Jan 2026 MDG Proposed Updates

Revision Type	Reference	Section Description (Red indicates Change of name from existing)	Description of Revision	New or Deletion	Primary POC
MDG	ALL Chapters	MANY	Editorial update throughout MDG to change "Shared Use" to "Shared-Use" to be consistent with MUTCD		Alford / Fiant
MDG	1.4	Definitions	Updated definitions for consistency with MUTCD		Alford
MDG	2.3.1.1	Planning Resources	Updated Streetlight Data Row to indicate account access provided through Office of Planning rather than Office of Roadway Engineering. Also, removed safety data available timeframe years in Walk.Bike.Ohio row.		Alford
MDG	Table 3-2	Mean Walking Speeds for Disabled Pedestrians and Users of Various Assistive Devices	Corrected walking speed for Above-knee amputee row in table		Alford
MDG	Figure 3-3	Example of Mutual Yielding Zones Illustrating Intersection Sight Distance Case A	Update figure to show current MUTCD bike symbol marking		Alford

Figure 3-6: Intersection Sight Distance: Bike Case C1 — Single Crossing Scenario

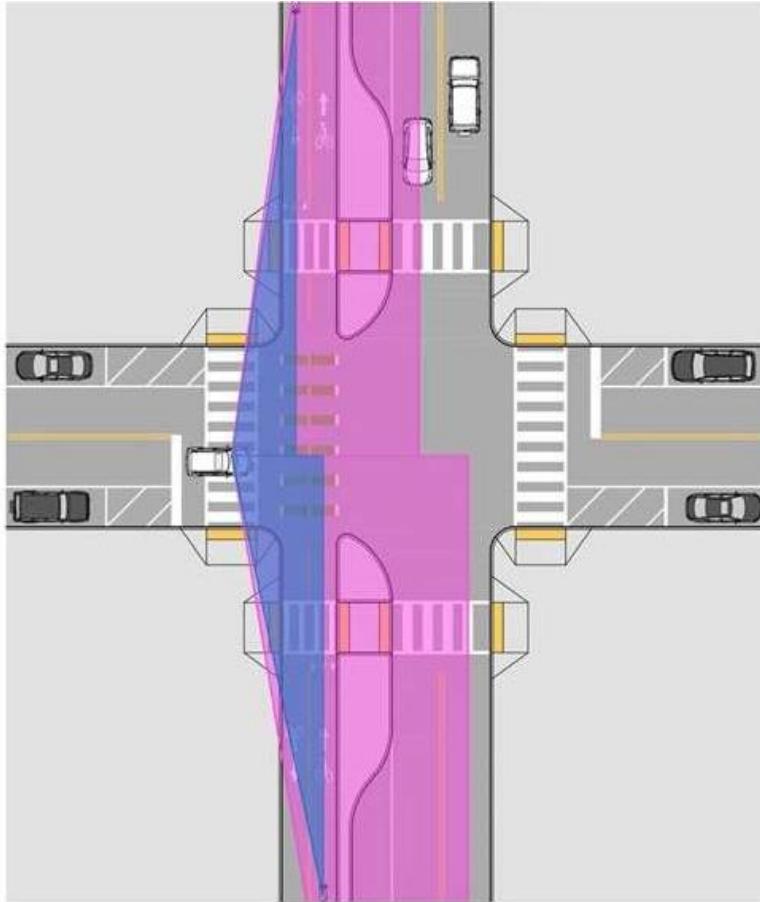
Commented [BS3]: Figure should be updated to contain the latest MUTCD bike symbol marking

Figure 5-9: Shared-Use Path Stops or Yields

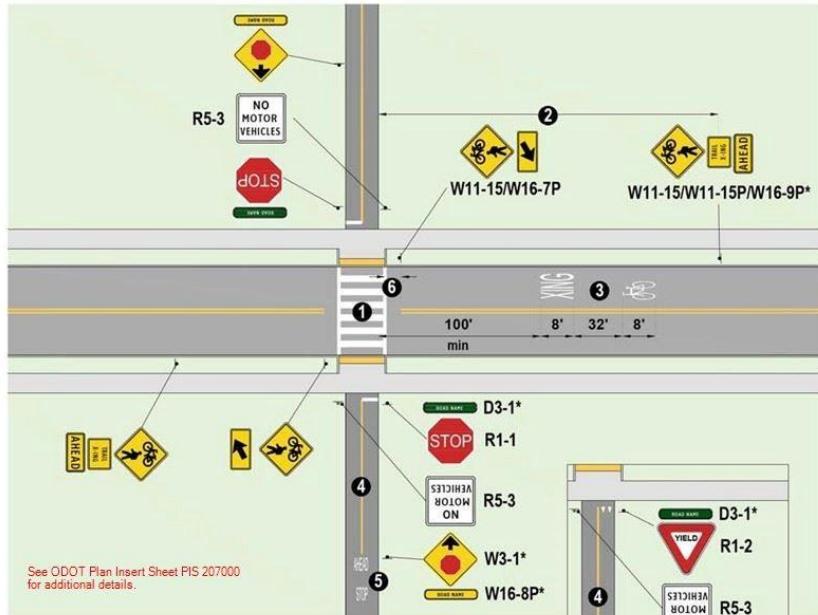
Commented [TK1]: Point 2 - Please update to table 2C-3 of the OMUTCD

Figure 5-10: Shared-Use Path Stops or Yields near Railroad Crossing

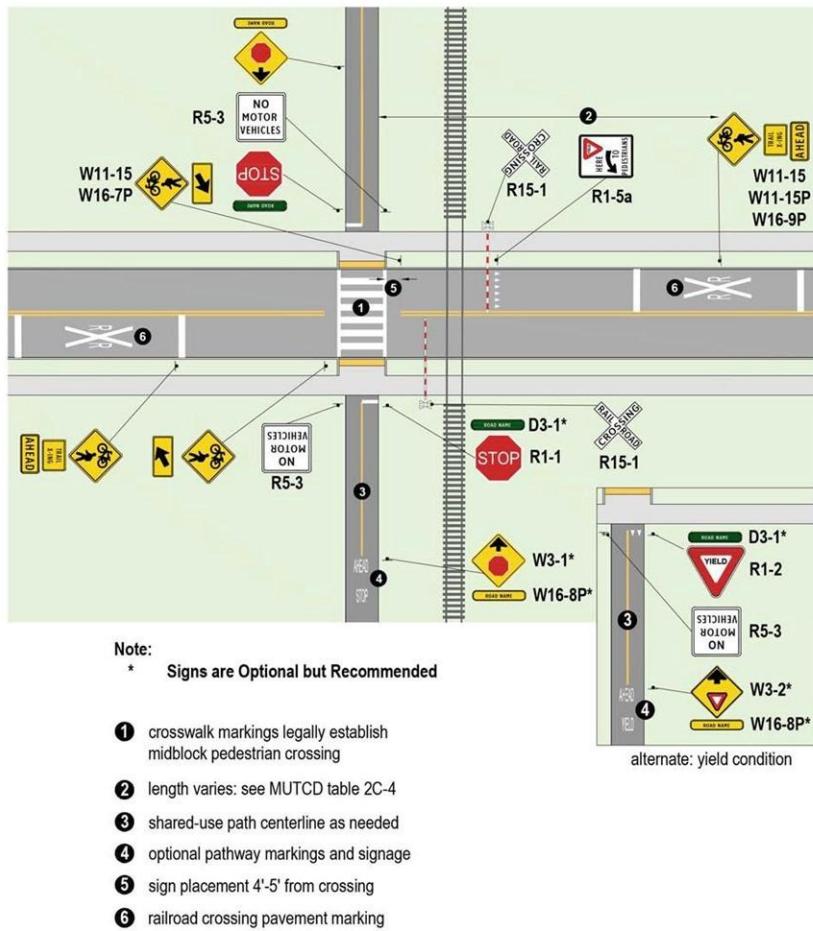
Commented [TK2]: Point 2 - Please update to table 2C-3 of the OMUTCD

Figure 5-11: Road Stops

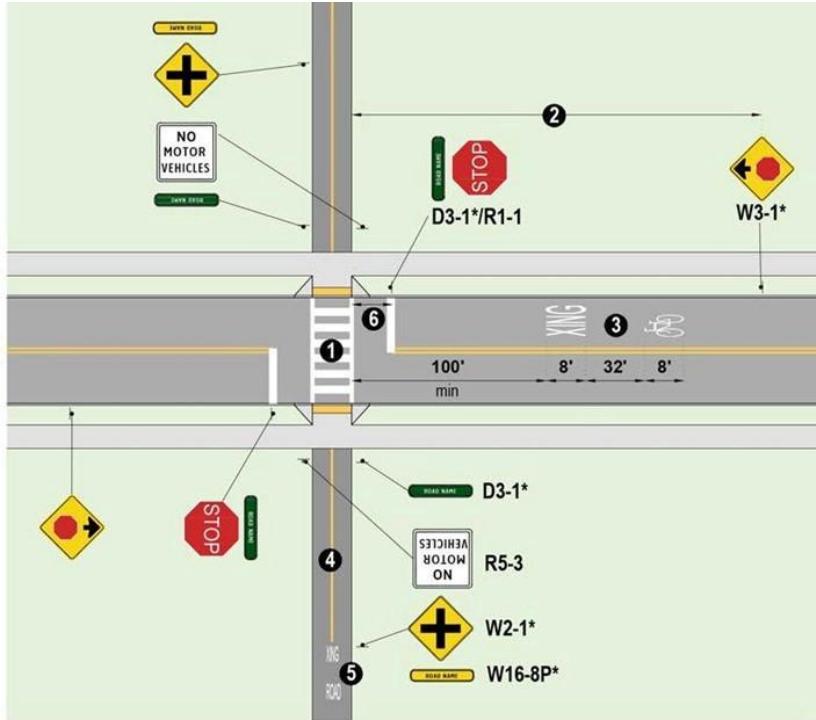
Commented [TK3]: Point 2 - Please update to table 2C-3 of the OMUTCD

Figure 5-12: Multi-lane Road Uncontrolled with Advance Yield Line

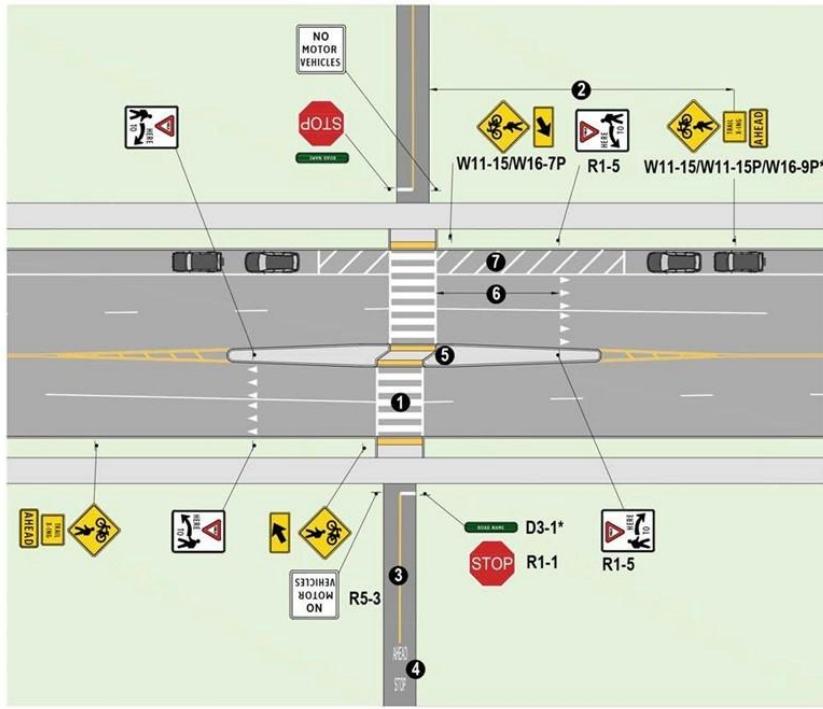
Commented [TK4]: Point 2 - Please update to table 2C-3 of the OMUTCD

Figure 6-2: Shared-Lane Markings Lateral Placement

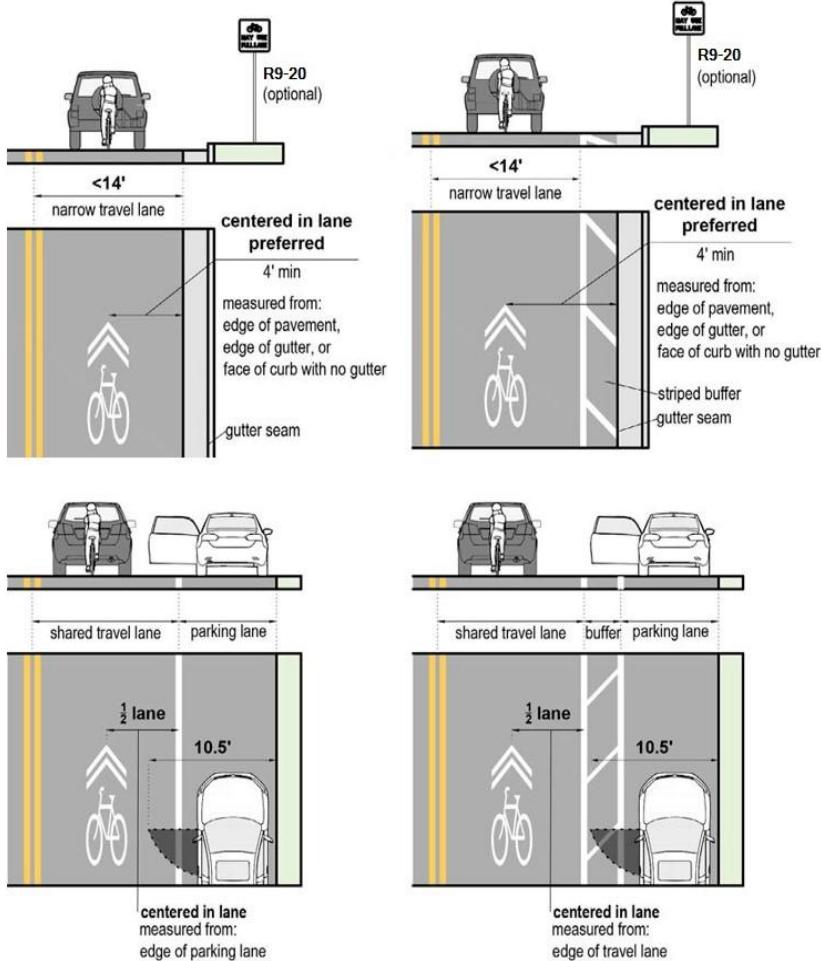
Commented [JW19]: This is more restrictive than the MUTCD (12 feet from face of curb, which would be 4-5 feet into the travel lane with an 8-foot parking lane) - confirm that that is the intent.

Commented [DS20R19]: MUTCD 9E.09 P07 suggests a minimum of 12 feet from the face of curb on roads with on-street parallel parking. As described in this paragraph and In Figure 6-2 example with parallel parking indirectly shows a distance of at least 12 feet. This could be improved by adding a 3rd dimension from center of marking to face of curb.

Figure 6-3: Longitudinal Placement and Intersection Navigation Examples of ~~Shared-Lane~~Shared-Lane

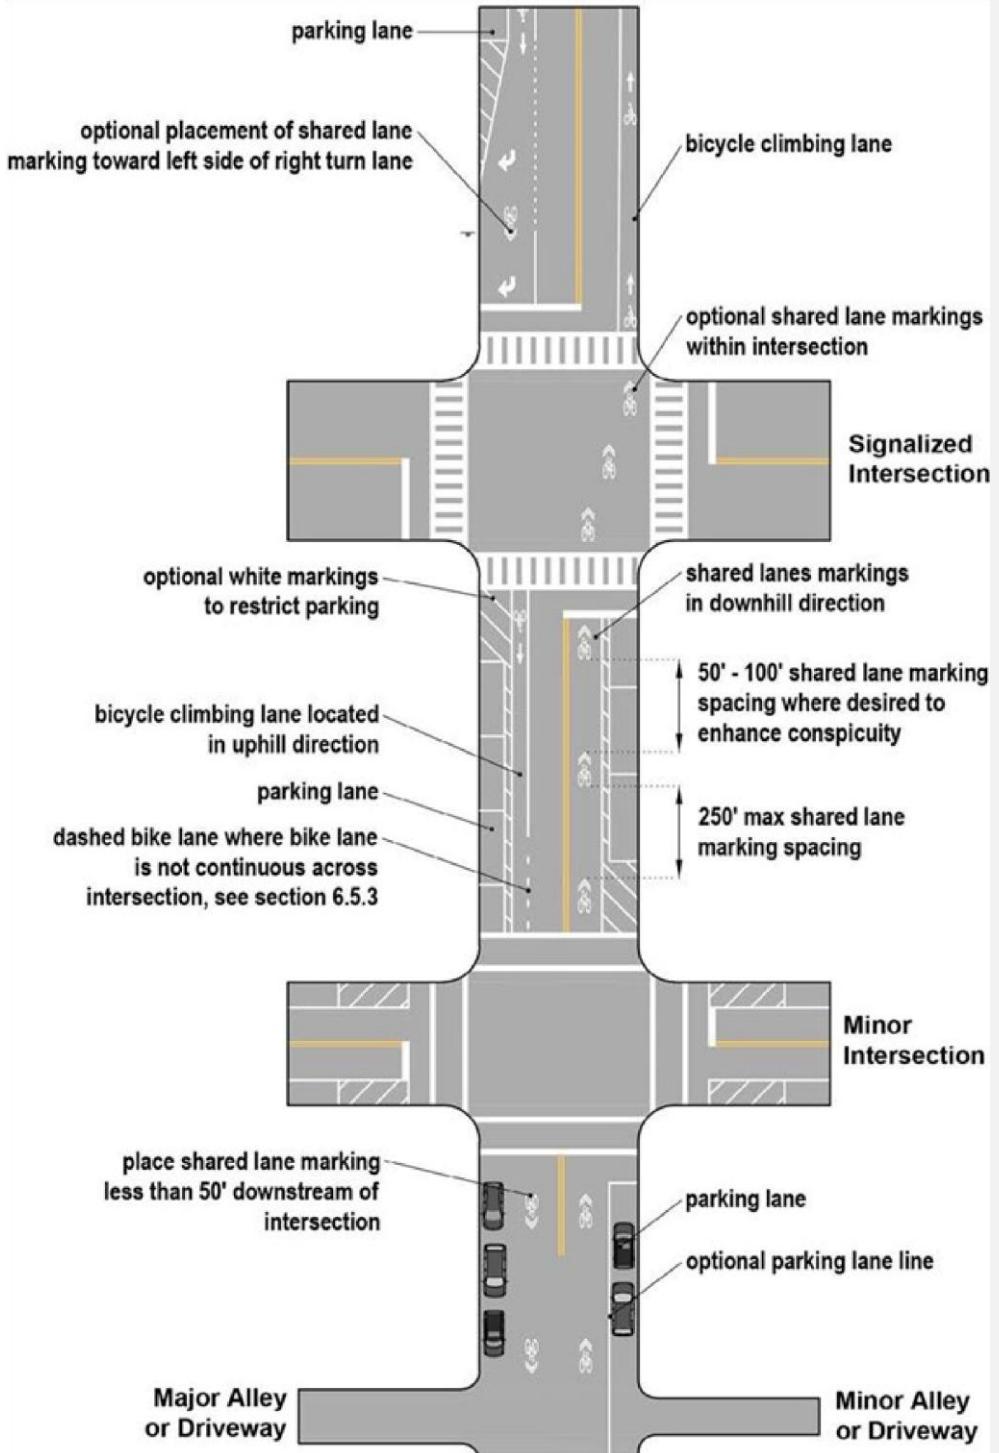
Commented [JW29]: Update figure to remove shared lane intersection guide markings per Section 9E.09 P 04 line B.

Commented [JA30R29]: Agree.

Figure 6-6: Typical Bike Lane Pavement Markings and Traffic Control Signs

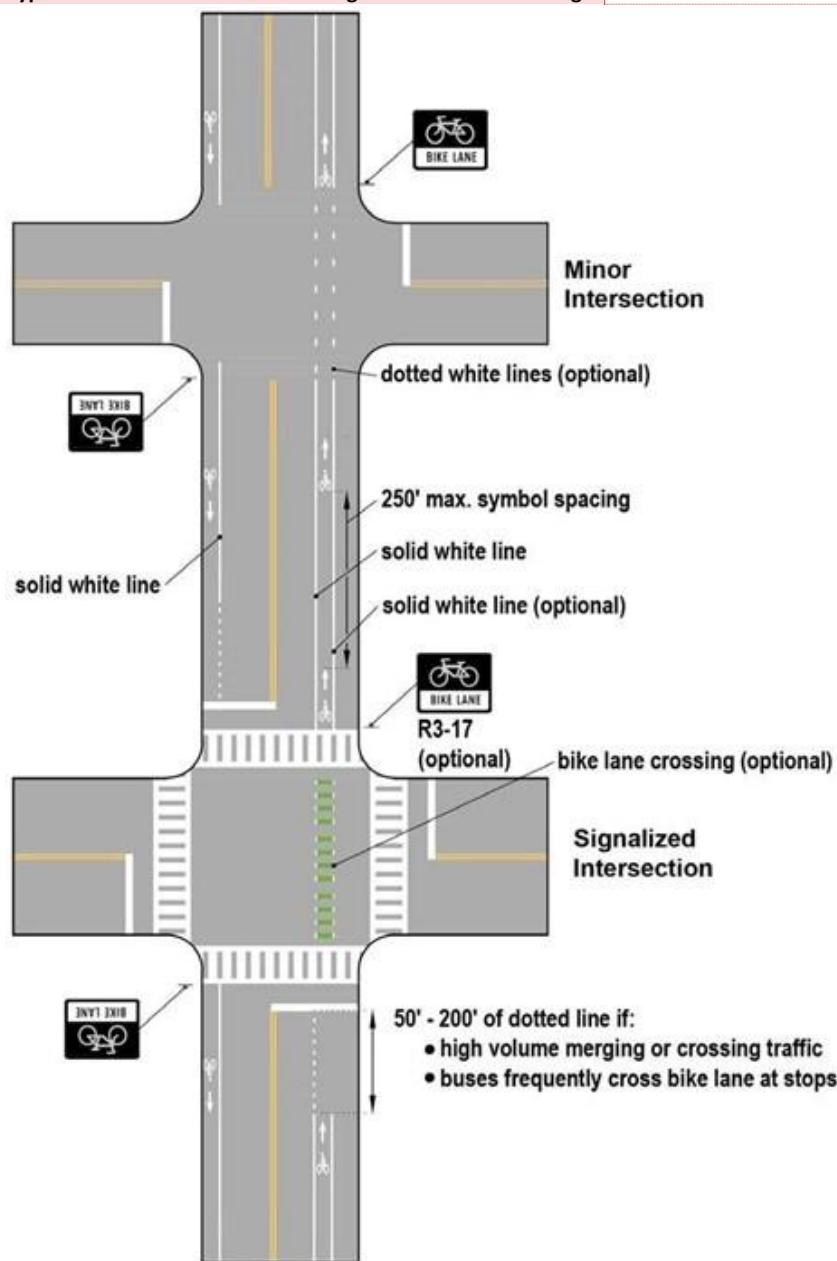
Commented [JW50]: Update bike lane markings per MUTCD

Figure 6-7: Example of Door Zone Markings in Constrained Bike Lane Conditions

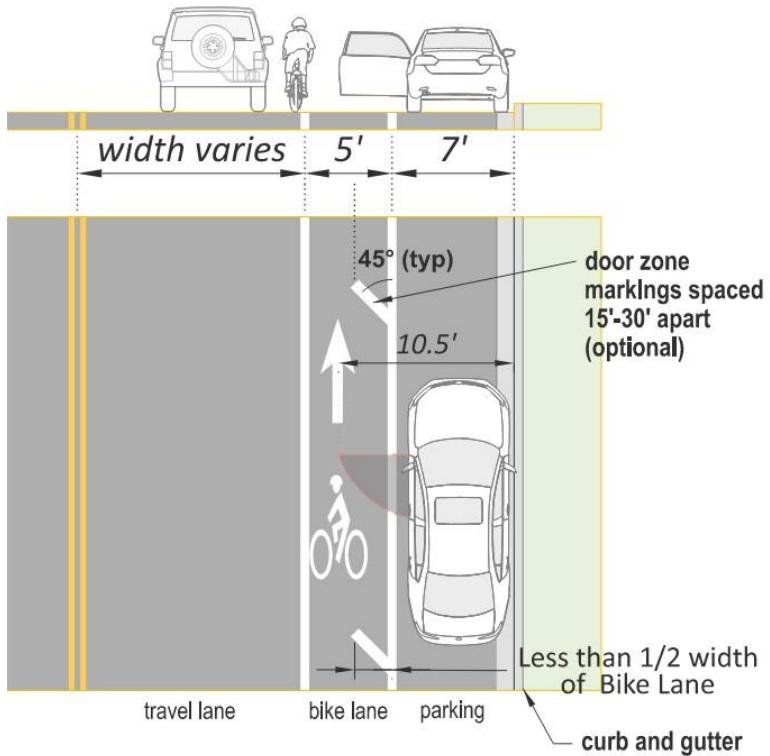
Commented [JW51]: Update bike symbol per MUTCD

Figure 6-8: Design Criteria for Back-in Angled Parking

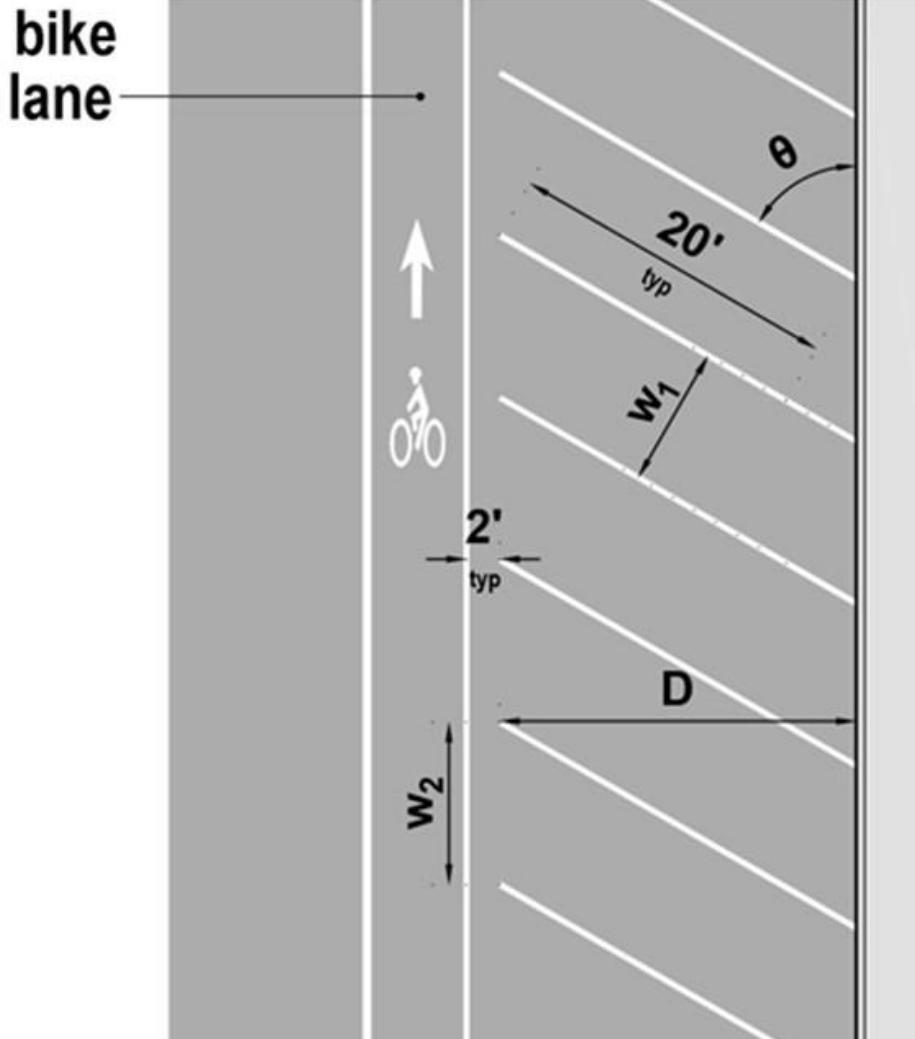
Commented [JW52]: Update bike symbol per MUTCD

Figure 6-10: Raised Bike Lane Examples

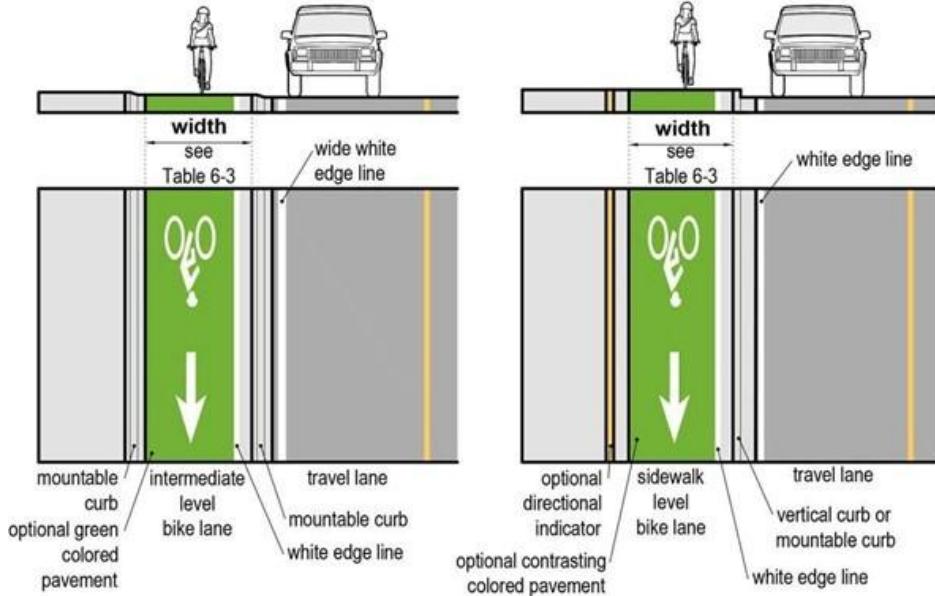
Commented [JW62]: Figure needs updating with new bike symbol

Figure 6-13: Examples of Separated Bike Lane Drainage Configurations

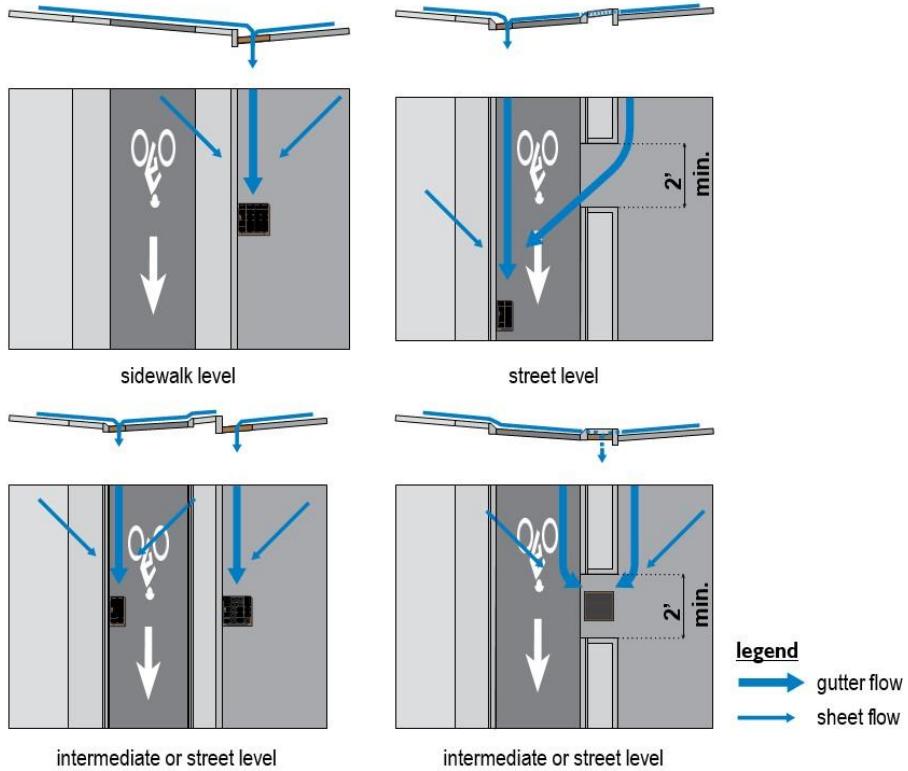
Commented [JW66]: Update with latest bike symbol per MUTCD

Figure 6-20: Transition from One-Way to Two-Way Separated Bike Lanes with Two-Stage Turn Box

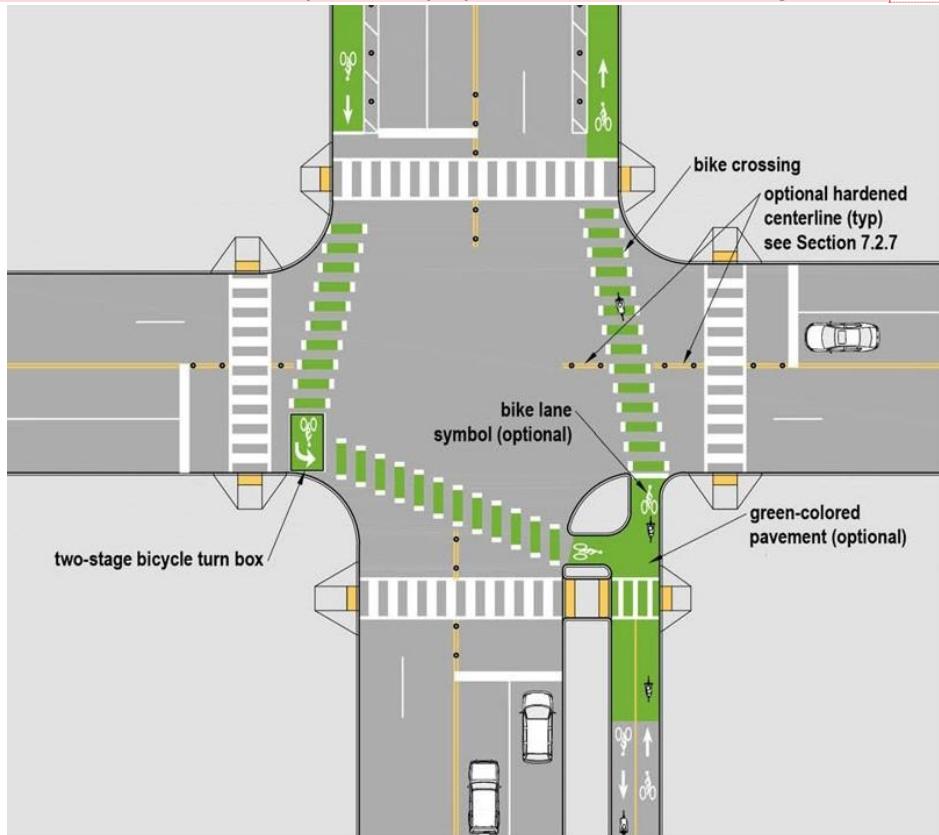
Also, the two-stage turn box for the south side two-way cycle track is not MUTCD compliant. It should have a single through arrow for the two bicycle directions. (Note this is not what most agencies do, but is what is what the MUTCD specifies) Section 9E.11 P 06 and Figure 9E-11
